SUBJECT: RFI/RI Work Plan for the Early Construction and Operational Disposal Site L-3 (NBN), L-Area Rubble Pit (131-1L), and L-Area Rubble Pit (131-4L) Operable Unit (U) (SRNS-RP-2021-05602, Revision 1 Redline, July 2022), Savannah River Site's Responses to the Regulatory Comments on the Revision 0 Document, and the Revised Implementation Schedule, SEMS Number: 91

2. SRS Responses to SCDHEC Comments on the RCRA Facility Investigation/Remedial Investigation Work Plan for the Early Construction and Operational Disposal Site L-3 (NBN), L-Area Rubble Pit (131-1L), and L-Area Rubble Pit (131-4L) Operable Unit (U) (SRNS-RP-2021-05602, Revision 0, February 2022)

3. SRS Responses to USEPA comments on the RCRA Facility Investigation/Remedial Investigation Work Plan for the Early Construction and Operational Disposal Site L-3 (NBN), L-Area Rubble Pit (131-1L), and L-Area Rubble Pit (131-4L) Operable Unit (U) (SRNS-RP-2021-05602, Revision 0, February 2022)

Figure CR-1.

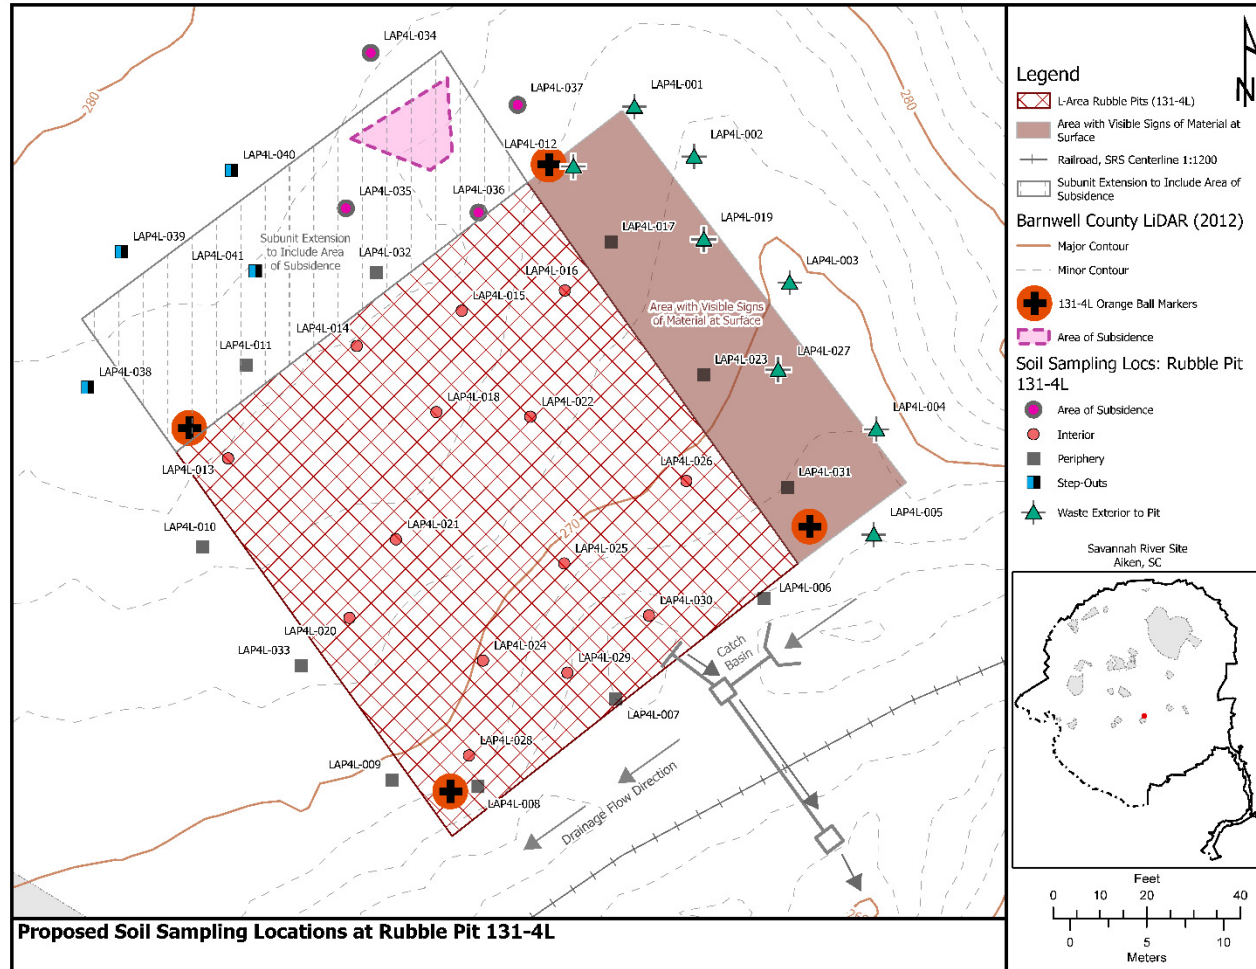
1. It is uncertain whether the number of proposed soil samples to be collected around the boundary of the LRP 131-4L subunit is adequate to define the nature and extent of contamination. For example, according to Figure 25 (Proposed RFI/RI Work Plan Sampling Locations for the LRP 131-4L Subunit), of the 12 perimeter subunit boundary soil samples proposed, only two sample locations (i.e., LAP4L-009 and LAP4L-010) are proposed along the 100 feet (ft) long southwestern side of the subunit. *Please revise the Work Plan to justify why this should be enough along the southwestern and northwestern sides of the subunit to ensure the extent of contamination is adequately defined.*

9. **Section 1.4.3, LRP 131-4L Subunit, Page 7 of 100:** The location of the blacktop and asphalt debris observed on the ground surface and discussed in the text is not depicted on a site map (e.g., Figure 25, Proposed RFI/RI Work Plan Sampling Locations for the LRP 131-4L Subunit). As such, the location of the blacktop and asphalt debris relative to the subunit boundaries and proposed sample locations is unclear. *Please revise the Work Plan to address this issue.*

Sample locations within the LRP 131-4L subunit were chosen using a random, unbiased sampling pattern spaced 6.1 meters (20 feet) apart. The perimeter sample locations were chosen manually to best define the subunit, with more locations placed on the two eastern sides based on topography to capture any potential contaminant migration by surface runoff. However, SRS agrees with the comment and therefore proposes one additional location on the southwestern side (LAP4L-033) and one additional location on the northwestern side (LAP4L-032) of the subunit (Figure CR-1). Location LAP4L-009 was moved to best distribute the locations on the southwestern side. The revised LRP 131-4L sampling locations will ensure the extent of contamination is adequately defined.

Figure ES-3, Page ES-9:
Revised as shown in Figure CR-1.

Figure 25:
Revised as shown in Figure CR-1.

The debris that was observed in the field at LRP 131-4L was observed in multiple locations scattered throughout the subunit. As a result, the proposed sampling approach includes sampling locations within and beyond the defined area of the unit boundary as indicated by the addition of sampling locations to the northeast of the unit. Figure CR-1 indicates the area where surficial material was noted on surface northeast of the unit. Without accurate spatial reference for the observations, depicting the numerous locations of debris would not be accurate. No further change to Figure 25 is recommended.

Figure CR-2.

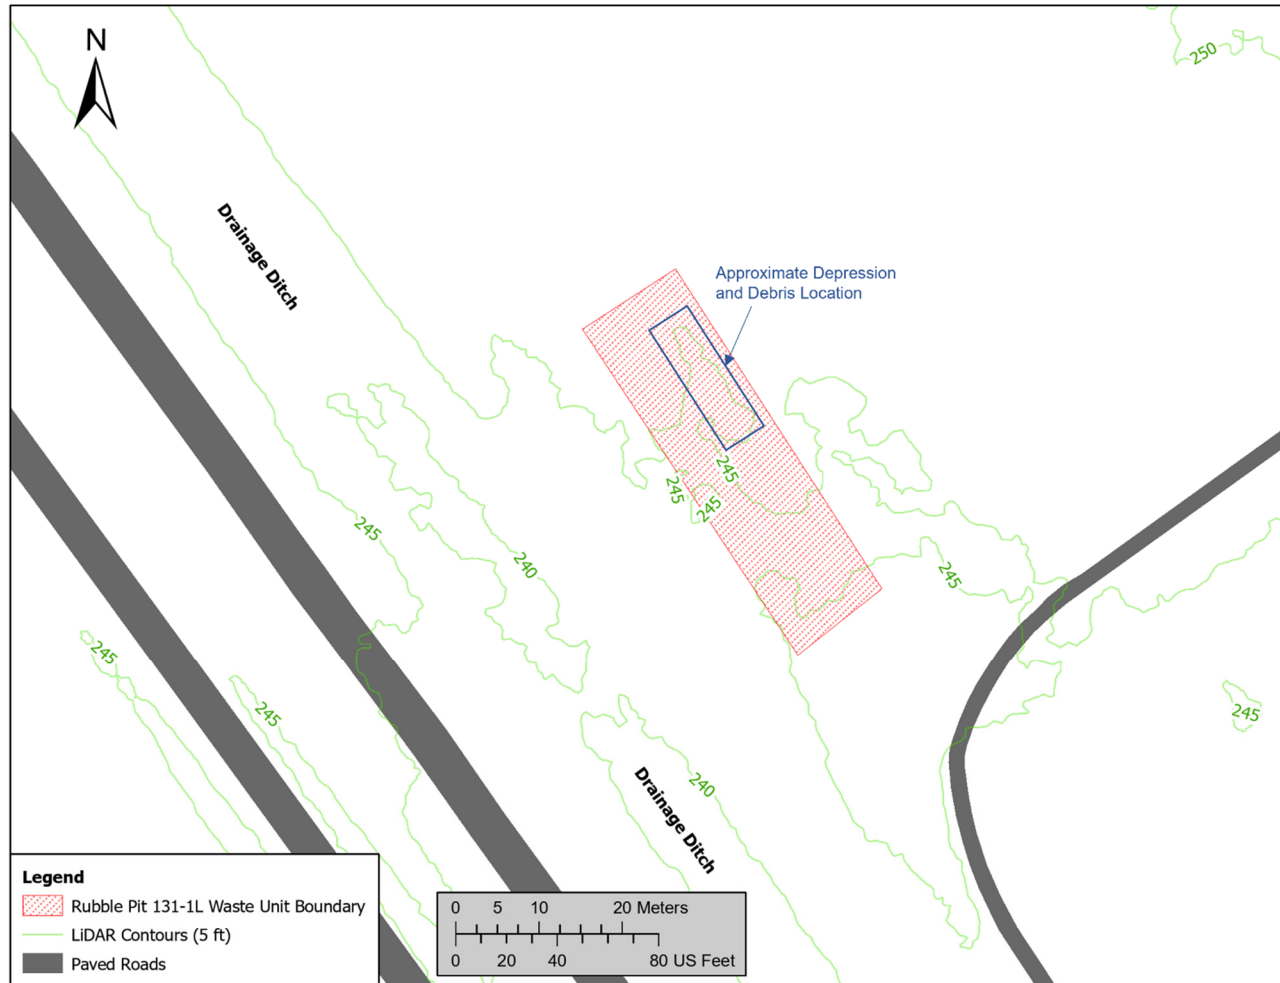
6. **Section 1.4.2, LRP 131-1L Subunit, Page 6 of 100:** Section 1.4.2 indicates that asphalt debris and an obvious depression were observed on the ground surface within the subunit during a site visit on December 7, 2021; however, the location of these observations discussed in the text is not depicted on a site map (e.g., Figure 24, Proposed RFI/RI Work Plan Sampling Locations for the LRP 131-1L Subunit). As such, the location of the asphalt debris and ground surface depression relative to the subunit boundaries and proposed sample locations is unclear. *Please revise the Work Plan to address this issue.*

The asphalt debris was observed on the edge of the depression and within the defined boundary of the Rubble Pit. The locations of the observations were not surveyed and therefore exact locations are not able to be provided. However, the relative location and size of the depression, including the asphalt debris, will be added to Figure 7 and Figure 24 of the Work Plan, as shown below in Figure CR-2 and Figure CR-3, respectively.

Figure CR-4.

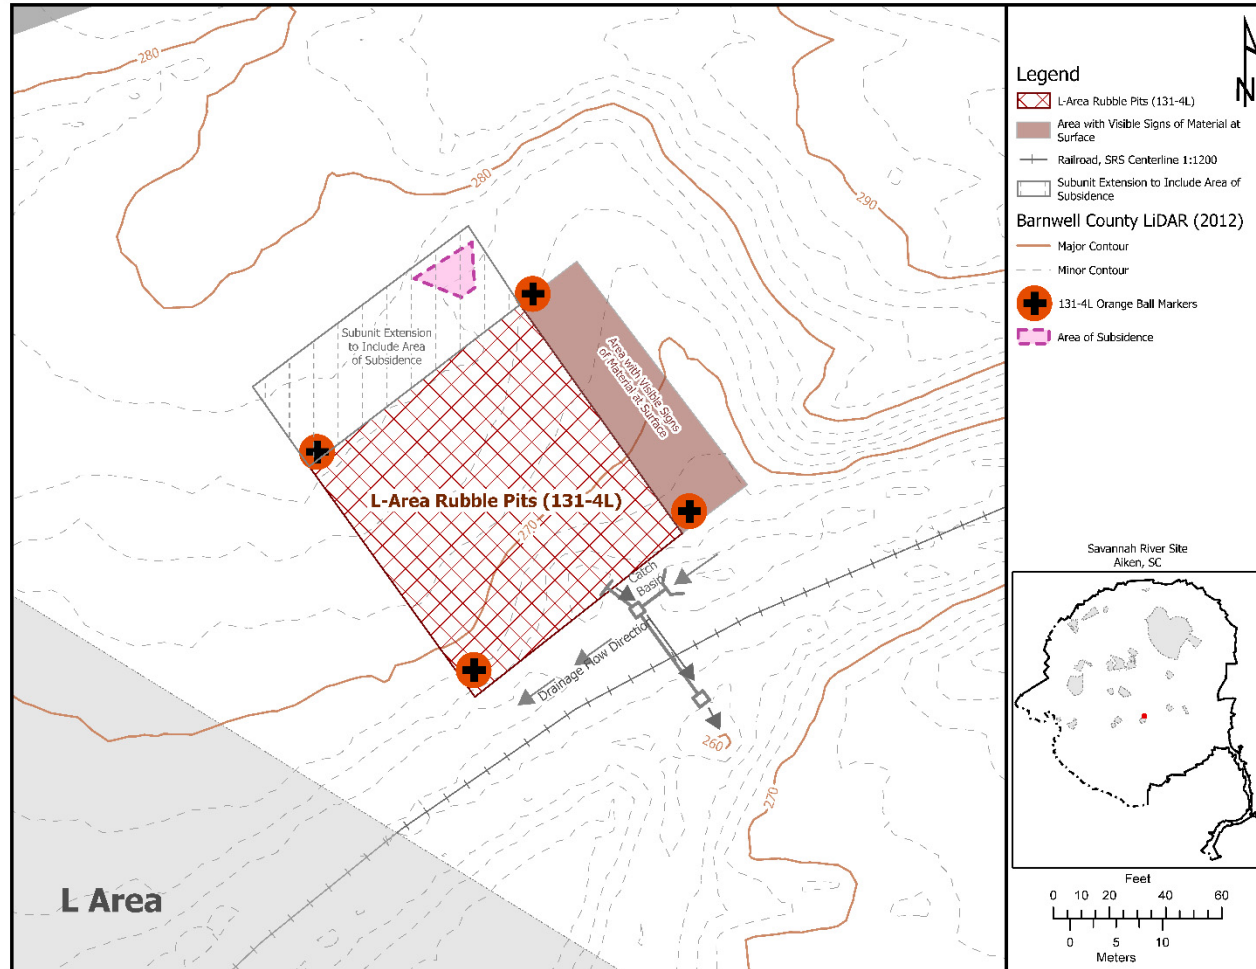
8. **Section 1.4.3, LRP 131-4L Subunit, Page 7 of 100, and Section 3.1.5.3, LRP 131-4L Subunit, Page 26 of 100:** The dimensions discussed in these sections for the subunit boundary of 120 ft by 100 ft expanded to include the land disturbance area identified during the 1994 site evaluation are not consistent with the dimensions presented on the site figure. For example, according to Figure 12 (LRP 131-4L Subunit Boundaries and Topography), the subunit boundary appears to be 100 ft by 100 ft and square shaped and does not include the land disturbance area. *Please revise the Work Plan to address this discrepancy.*

Figure 12 was revised as shown in **Figure CR-4**.
